Service Information

SERVICE TOOL VERSION UPGRADE (Ver.1.5.2.0)

1. Model Name PN-L803C, PN-80TC3, PN-L803CA, PN-80TC3A
2. General The version of the service tool has been upgraded.
3. Description Service Tool Ver.1.5.2.0

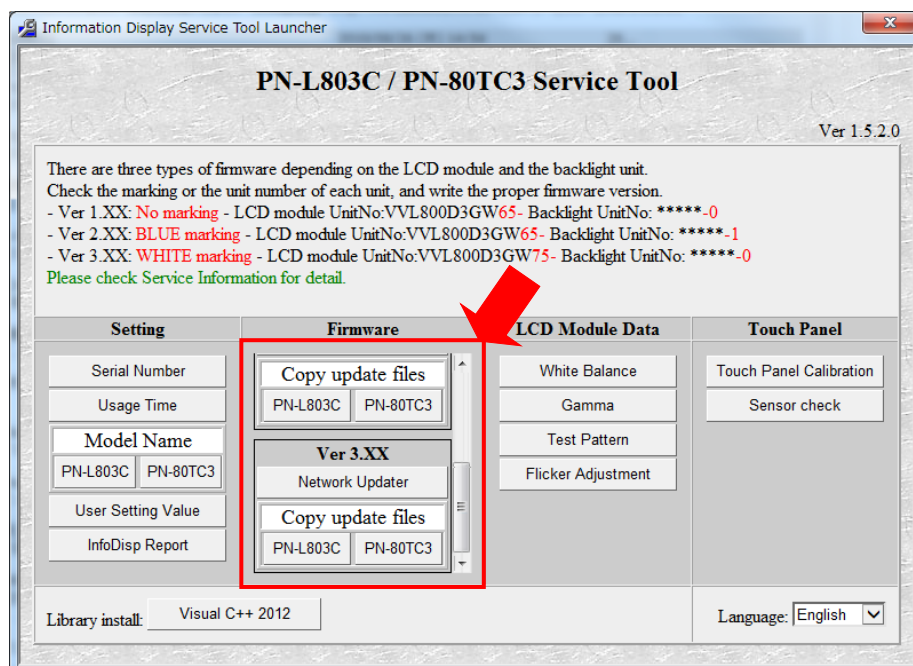
UI has been modified to select three types of firmware (Ver.1.XX, Ver.2.XX and Ver.3.XX).

Please refer to Service Information PNF-A798 for proper use of Ver.1.XX and Ver.2.XX.

Ver.3.XX is for PN-80TC3A manufactured for Europe in August and September 2019. Refer to Service Information PNF-A806 for tentative part change for August and September 2019 production.
